Application No.: 10/761,984

Docket No.: JCLA11903

REMARKS

Annotated Marked-up drawing**FIG. 1A(PRIOR ART)****FIG. 1B(PRIOR ART)**

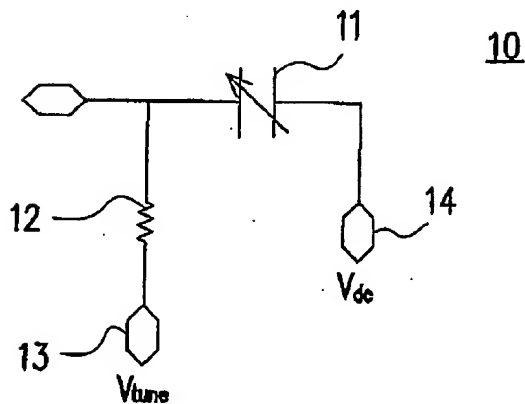
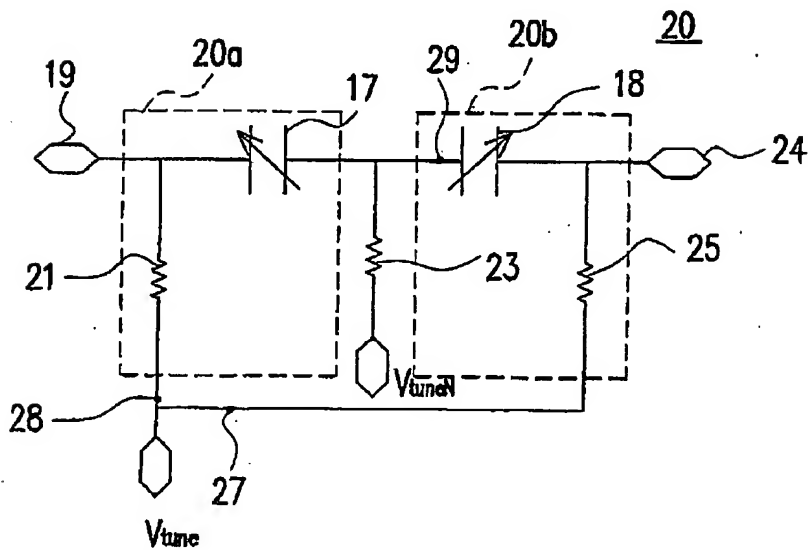
Figures 1A, 1B and 1C were objected to because the legend "Prior Art" should be added. The Office Action objected claim 4 as having minor errors. Claims 4-7 are pending. Claim 4 is rejected under 35 U.S.C. 102(b) as being anticipated by Scoggins (US-6,469,587, "Scoggins" hereinafter). Applicants have amended claim 4. After entry of the foregoing amendments, claims 1-7 remain pending in the present application, and reconsideration of those claims is respectfully requested.

FIG. 1A, FIG. 1B, and FIG. 2B have been amended to include the missing "Prior Art" designation as stated by the Examiner in the Office Action. They are presented in the appendix.

FIG. 1A, FIG. 1B, and FIG. 2B have been amended to include the missing "Prior Art" designation as stated by the Examiner in the Office Action. They are presented in the appendix.
